Office Action Summary	Application No. 10/567,459	Applicant(s) LUPTON, HENRY WILLIAM	
	Examiner SEAN P. DOUGHERTY	Art Unit 3736

This is the FINAL Office action based on the 10/567459 application filed 07/21/2006.

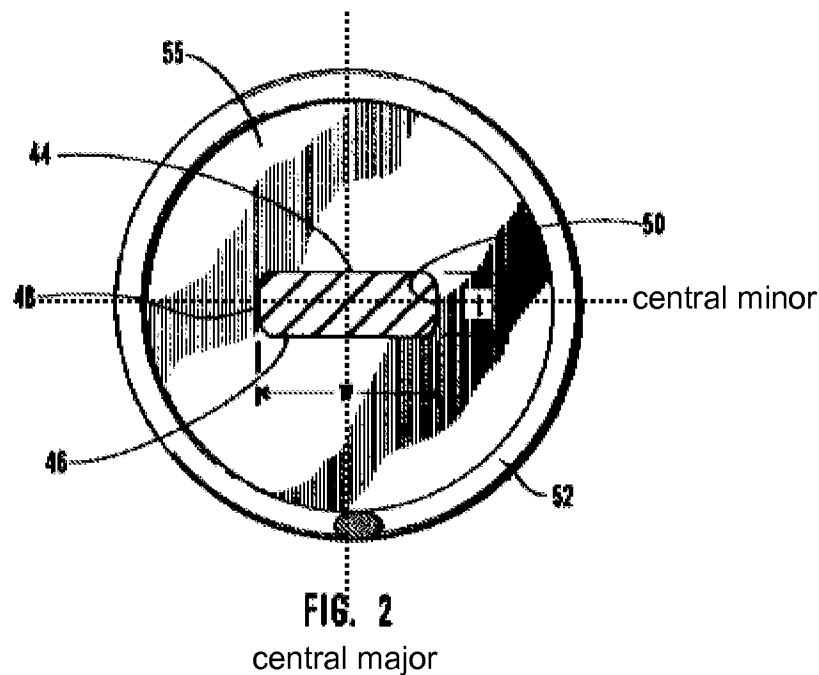
Claims 76, 78, 82-84, 87, 88 and 98-105 rejected under 35 U.S.C. 102(b) as being anticipated by US 5957865 to Backman, et al. (hereinafter “Backman”).

Regarding claims 76, 87, 88 and 99, Backman discloses:

- an elongated guide wire (10) for use in a surgical or other procedure for accessing a remote site in the body of a human or animal subject,
- the guide wire defining a longitudinally extending central axis (through the central axis of the guide wire extending from element 14 to element 58), and
- extending axially between a distal end (22) for accessing the remote site, and
- a spaced apart proximal end (14), and comprising
- an elongated core wire (see Figure 1) extending from the proximal end and terminating in a distal portion adjacent the distal end of the guide wire,
- the distal portion of the core wire being of substantially rectangular transverse cross-section (see Figure 2) defining
- a pair of spaced apart major surfaces (t), and
- a pair of spaced apart minor surfaces (w) extending between the major surfaces, and further defining

- a central major plane lying intermediate the major surfaces and bisecting the minor surfaces (see Figure 2, below), and
- a central minor plane lying intermediate the minor surfaces and bisecting the major surfaces (see Figure 2, below), wherein
- the distal portion of the core wire is bent into a curved configuration in the central major plane for forming an alignment portion lying in the central major plane and extending from the bend at an angle greater than zero relative to the central axis for facilitating guiding of the guide wire into a branched vessel of the subject (col. 6, ll. 37-46).
